Modification of 804544 and 804569

Part Number: 804544 / 804569

For Vehicle: Renault, Nissan, Dacia applications

New design of 804544 / 804569

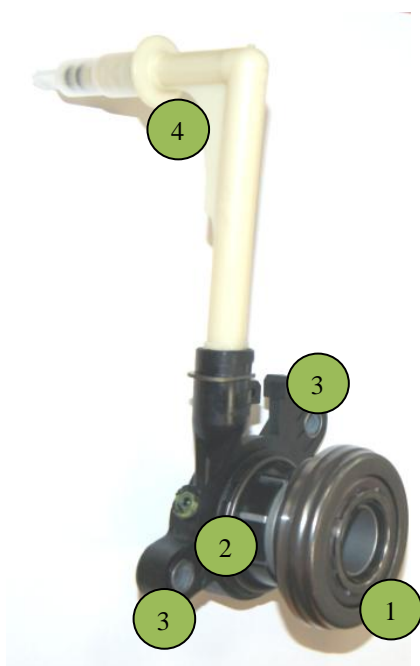
Please note there have been several design changes on concentric slave cylinders 804544 and 804569.
The changes are as follows:

- Seal with metallic insert > full rubber seal 80Sh
- New plastic piston (1)
- Removal of rubber boot (2)
- Ribs on the bolt fixing body (3)
- Improved hydraulic pipe (4)
